2022–2023 Granite State Landfill Baseline Environmental Studies

Sampling and Analysis Plan

June 2022
Revised October 2023

Appendix I: NHDES/GSL Comment and Response on SAP Development

Figure 3-1. Sampling locations and pre-development subwatersheds.

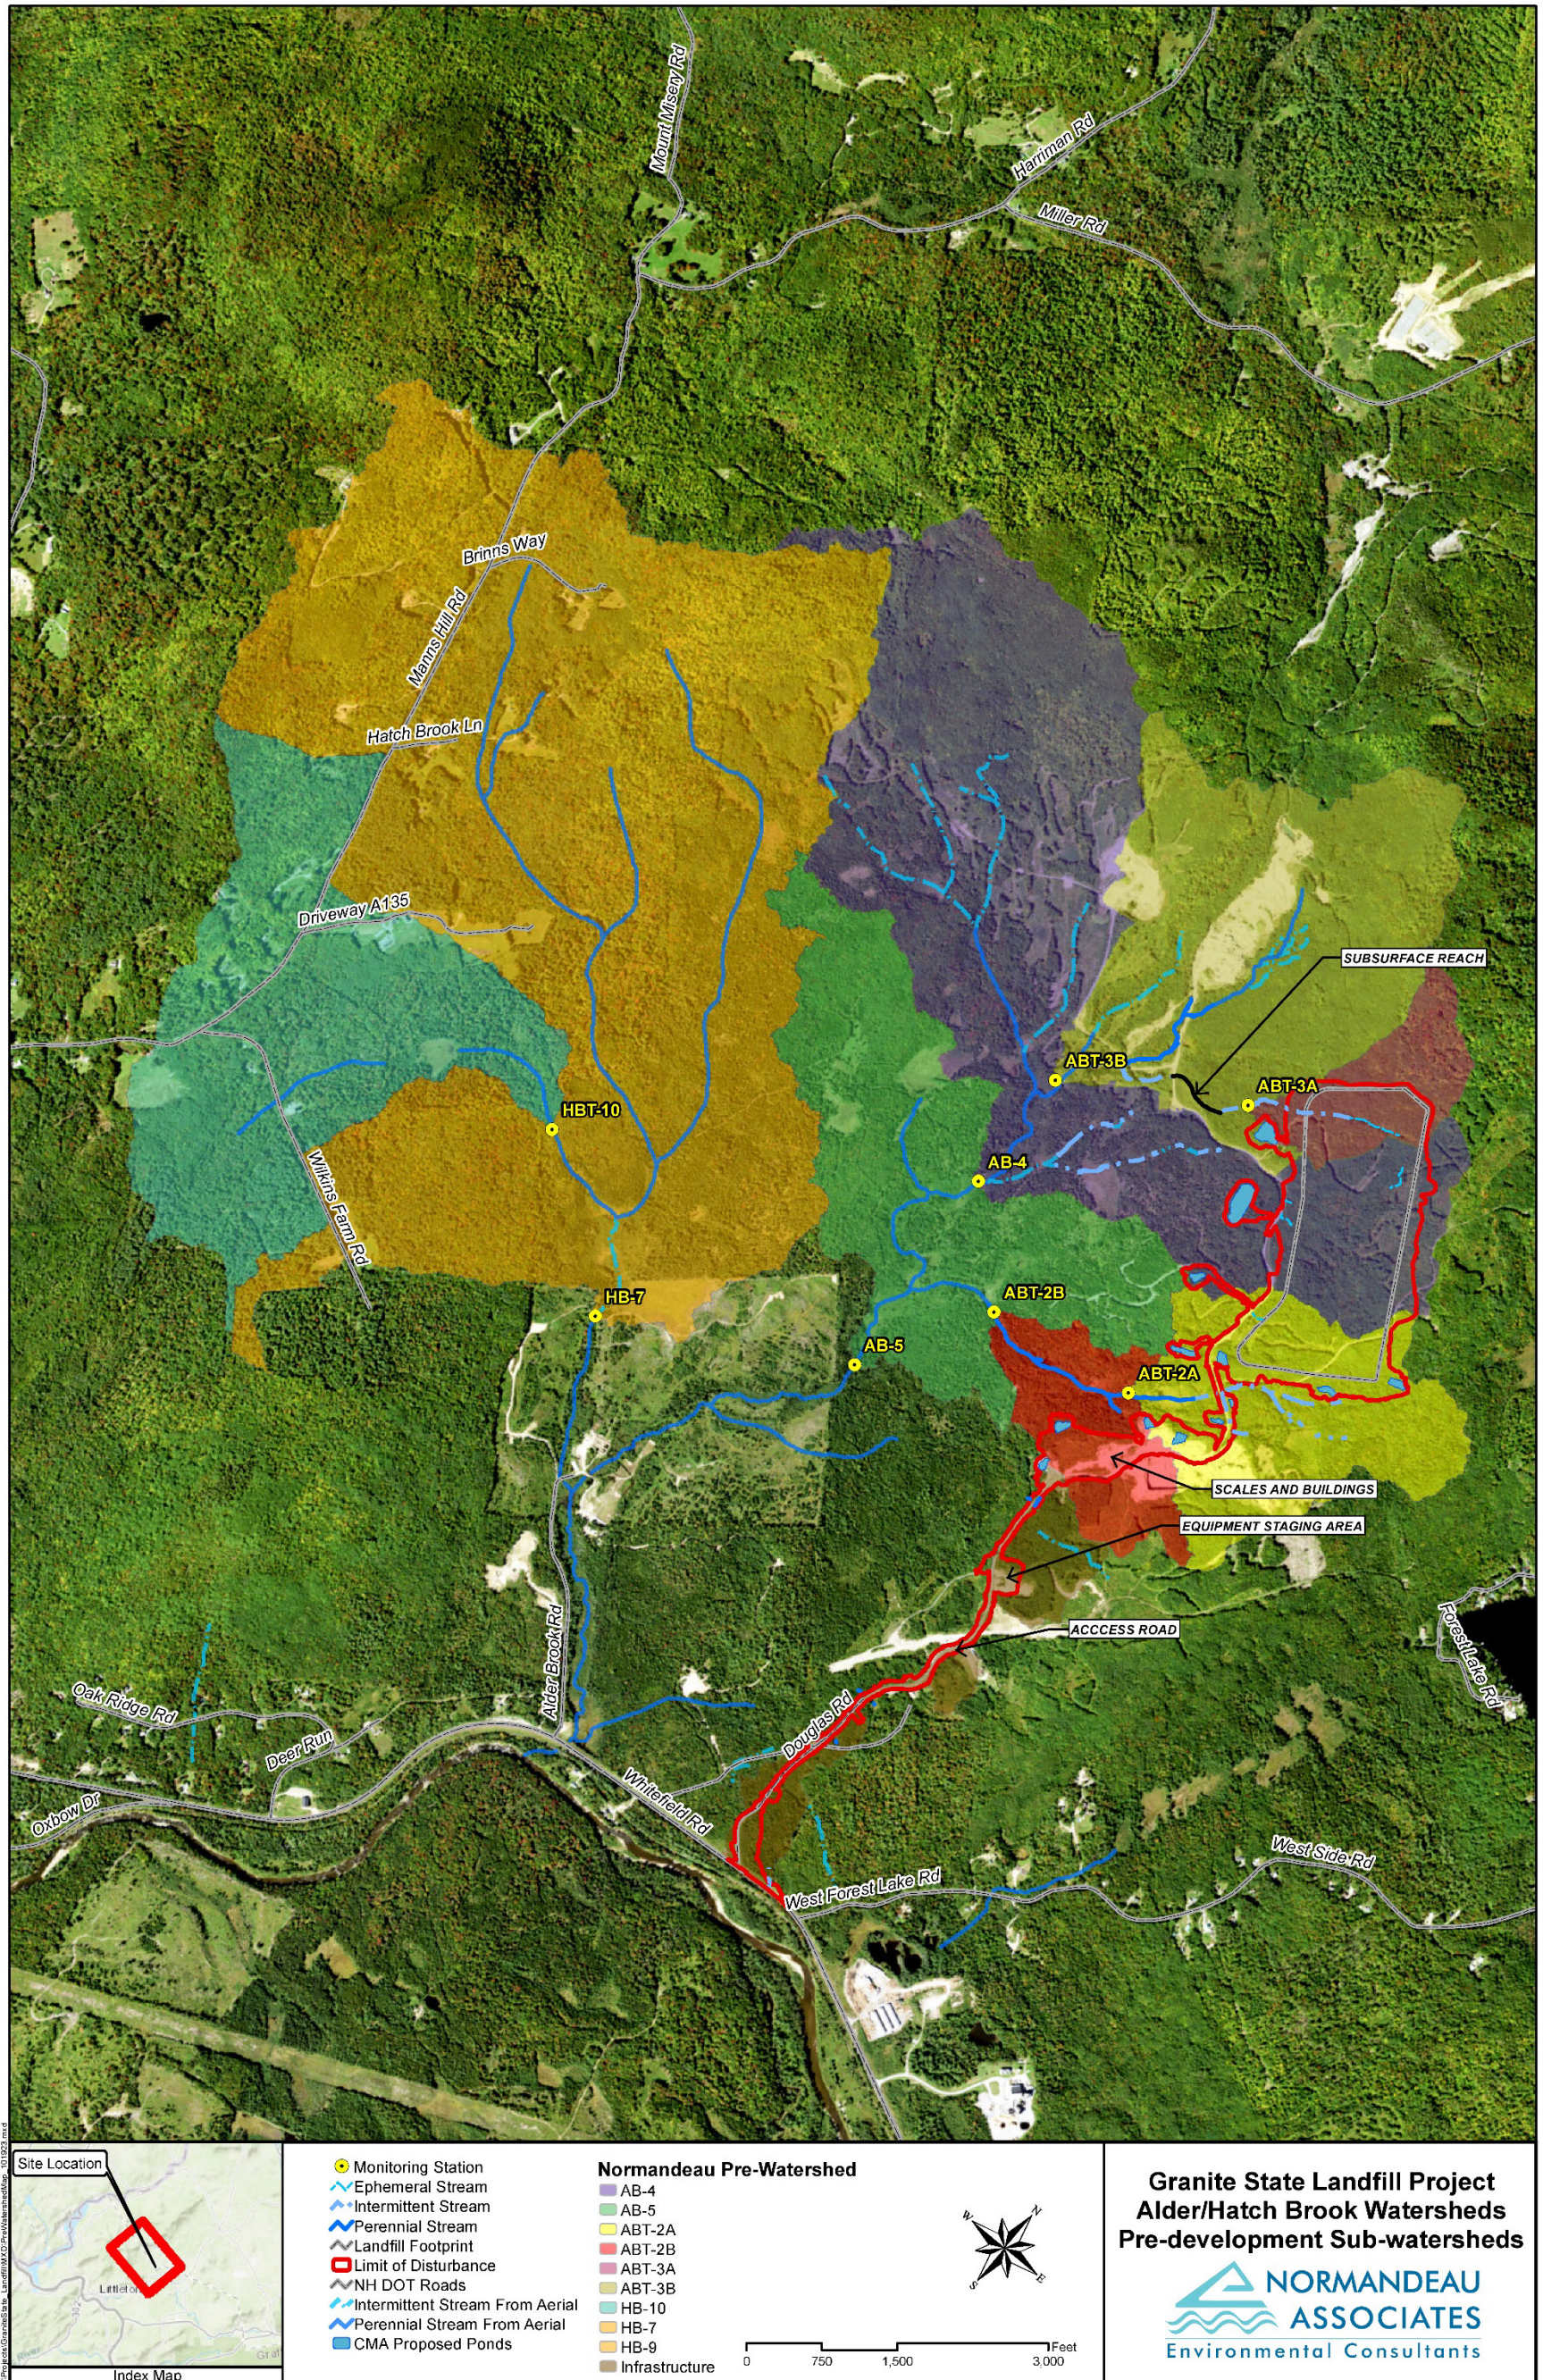
3. *3 Monitoring and Data Collection Methods and Locations; Figure 3.1 Proposed Sampling locations and subwatersheds* (pp. 4-6): In a revised SAP, NHDES recommends that GSL provide coordinates and photos of each proposed sampling or monitoring site location, including photos of the benthos at each sampling location to document the characteristics of the benthos (e.g., cobble, gravel, weedy, vegetation, etc.) at each location.

In a revised SAP, NHDES recommends that GSL provide maps that contain more detail than the map provided in Figure 3.1. Maps in the SAP should clearly show the following:

- b. Areas where stream segments are subsurface, to the extent possible, to provide more clarity on the connections of stream flow;

Figure 3.1 shows a purple line labelled as “PurchaseLots” in the legend of Figure 3.1. NHDES recommends that GSL explain if that line represents the boundary of the property owned or controlled by GSL. If that line represents the GSL’s property boundary, GSL should explain why the area labelled “Approximate Landfill Footprint” in Figure 3.1 is outside the property boundary. If it is not the property boundary, GSL should explain what “PurchaseLots” means.

Figure 3.1 in the Revised SAP no longer includes the road names that were included in the Original SAP. In a revised SAP, NHDES recommends that GSL include road names, especially considering GSL repeatedly references "Douglas Drive" to describe the location of monitoring locations in the Revised SAP.

- e. In Figure 3.1, GSL does not show a watershed in the southeast corner of the area labelled as “Landfill Footprint”. NHDES recommends that GSL revise Figure 3.1 to show the watershed of that area.

GSL Response: The proposed infrastructure for supporting landfill operations has been included in the updated Figure 3.1 included in the revised SAP. The final design may change from the current design included in Figure 3.1. The baseline environmental data collected in accordance with this SAP will be used to guide the refinement of the design. The focus of the baseline study is general environmental data collection and the monitoring site locations were selected to represent potentially affected areas from the full project buildout. No significant development will occur outside of the drainage areas captured by the proposed monitoring network. In addition, a reference reach is proposed located in a subwatershed outside of development areas to characterize baseline conditions and provide an opportunity for long-term monitoring of data trends.

GSL Response: perennial, intermittent, and ephemeral streams are indicated on Figure 3.1 and have been updated based on the most recent site visit.

GSL Response: Figure 3.1 has been updated to indicate the subsurface stream segments.

GSL Response: The stream segments potentially impacted by the project are indicated on the updated Figure 3.1 included in the revised SAP.

GSL Response: Project infrastructure is included on the updated Figure 3.1 included in the revised SAP.

GSL Response: The “PurchaseLots” line is the GSL property boundary. The “Approximate Landfill Footprint” line should not extend past the property line and has been corrected in the revised Figure 3.1.

GSL response: Douglas Drive has been labelled Figure 3.1 and Figure 3.2.

GSL response: Figure 3.1 had an error and did not correctly depict the watershed area for monitoring station 1. The site map has been updated with corrected watershed layers and is included in the revised SAP.

Modified Figure 3.1 of the Revised SAP showing the approximate location of the environmental sampling station recommended by NHDES.

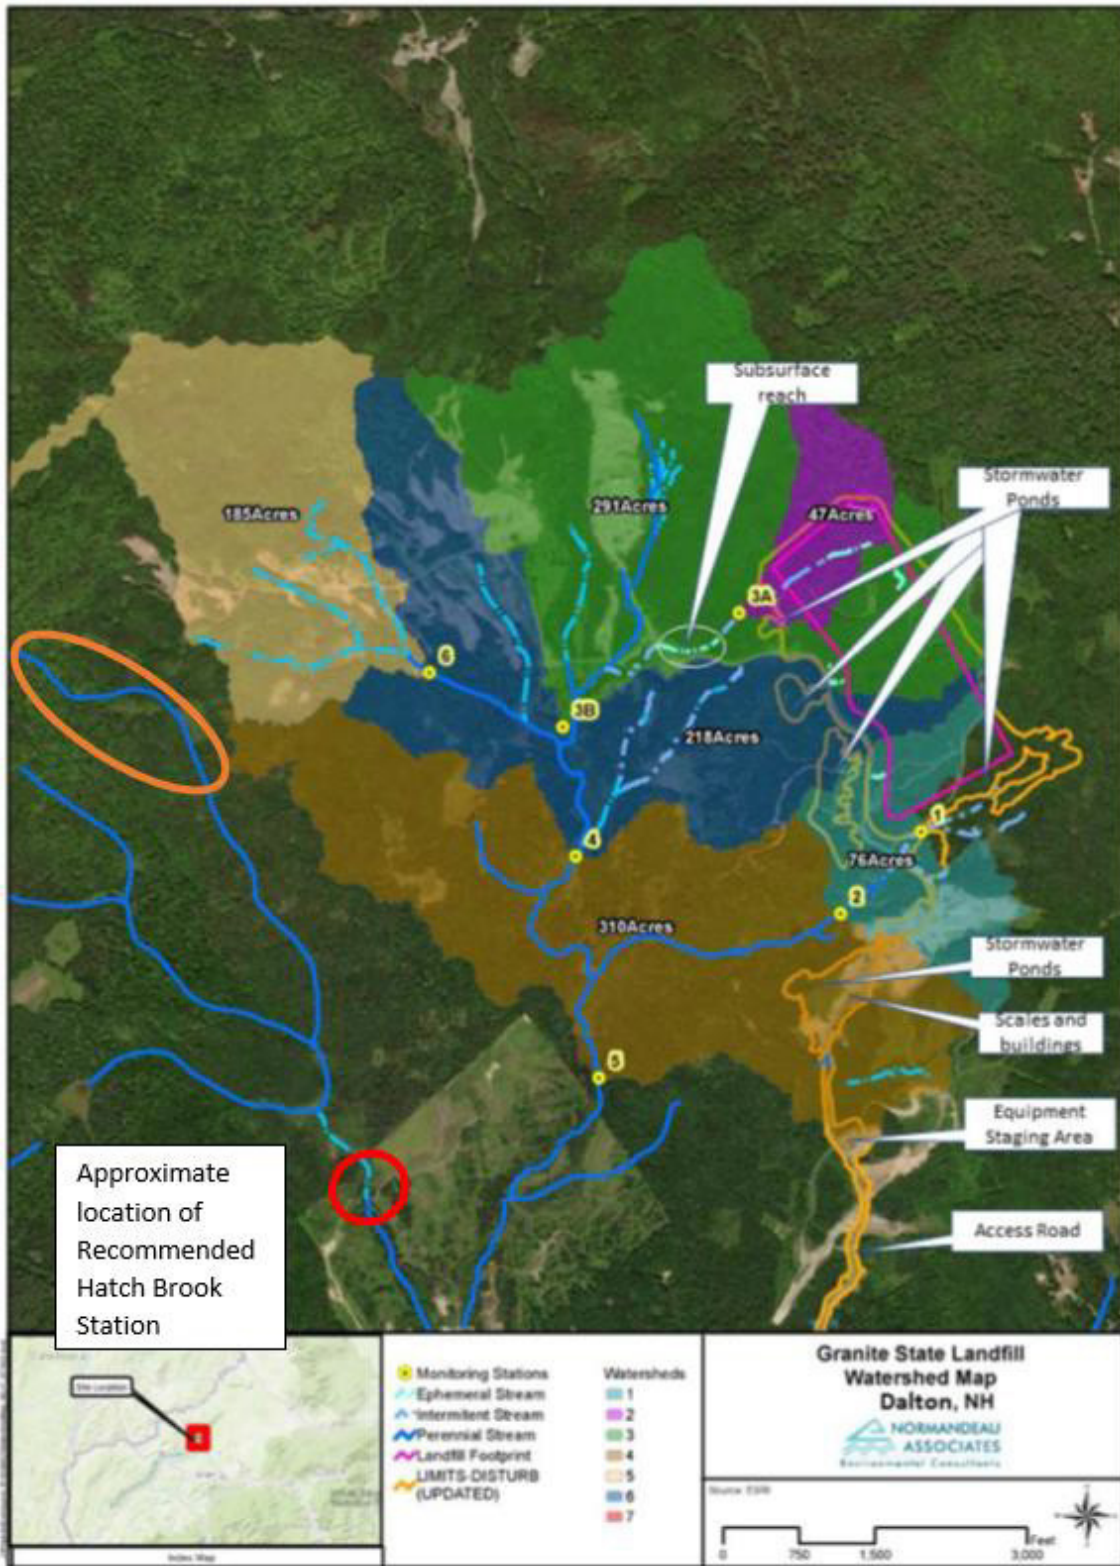
- b. NHDES recommends removing environmental sampling Station 6 and replacing it with a sampling station at a flowing stream segment of Hatch Brook watershed that is of the same stream order as Station 2 or Station 3b (see the orange circle in the modified version of Figure 3.1, below, for example locations). In the Revised SAP, GSL describes Station 6 as a “reference reach” that is “outside the drainage area of the proposed project but is within the drainage area of other industrial site uses including gravel operations and timber harvesting by the current landowner.” Station 6 is within the drainage area of industrial uses that could affect baseline environmental data. An environmental sampling station located in the upper watershed of Hatch Brook would provide a reference reach to collect environmental baseline data that would likely not be affected by industrial uses and could be used to characterize baseline environmental conditions that are more representative of natural conditions than Station 6. NHDES understands that GSL may select an appropriate station location on an upper reach Hatch Brook based on the criteria that GSL provided in this section of the Revised SAP. If the Project is constructed and implemented, an environmental sampling station at an upper reach of Hatch Brook could be used to collect environmental data that would be unaffected by construction and implementation of the Project to compare against data collected at stations on streams of the order that could be affected by the Project.

- c. If GSL decides to retain Station 6 despite NHDES’ recommendation to replace Station 6 in comment 1.b, above; NHDES notes that a small portion of the watershed area that GSL depicted for Station 6 that extends southwest to the edge of Figure 3.1 may not be accurate. NHDES recommends that GSL review the drainage area depicted for Station 6 to confirm the accuracy of the drainage area and make any revisions to Figure 3.1, if necessary, to correct the drainage area depicted for Station 6.

GSL response: An additional baseline environmental monitoring station on Hatch Brook (station HB-7) has been included with the revised SAP. The suggested location was used for siting the new station and the exact location is provided in the SAP. The suggested monitoring data will be collected beginning with the 2024 baseline study.
